SUBJECT: 6.0 L Water Pump Design Change Cooler Kit

AP63503 Water Pump

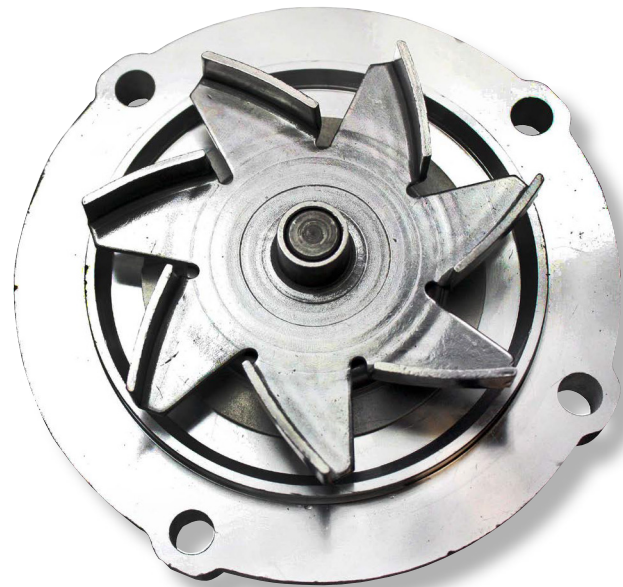
- The impeller on the AP63503 Water Pump has been upgraded from a black composite material to steel.
- This upgrade was implemented in June, 2010 and will increase the longevity of the water pump as well as eliminate impeller slippage and breakage issues.
- The dimensions and replacement procedure for the pump are unchanged.
- There have been no component changes to the AP63502 Water Pump at this time, as this pump has not experienced the level of failure as seen in the original version of AP63503.
